Andrea's comments to v4

Most of the comments are about style or to improve a bit further clarity. Only a few comments are substantial (indicated in bold) even if they can be fixed trivially.

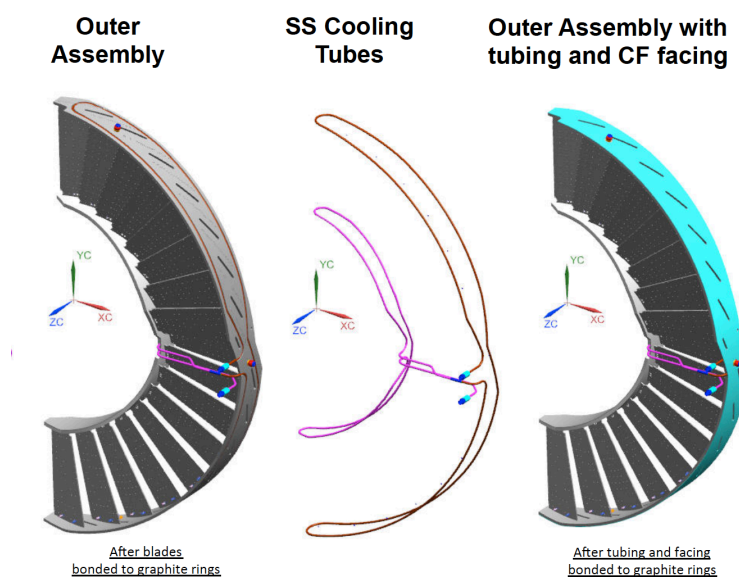
Lines 731 and 733: I realized that reading this sentence I don' get where the cooling loops are embedded: there are two rings (called assemblies in this section) in each disk and two cooling loops in each disk: one for each assembly. Each assembly has two graphite rings: an inner and an outer one. In which of the FOUR graphite rings are the TWO cooling loops? → One cooling loop goes through both, the outer and inner graphite ring of an assembly (see picture below). We are open to suggestions on how to make this more clear.
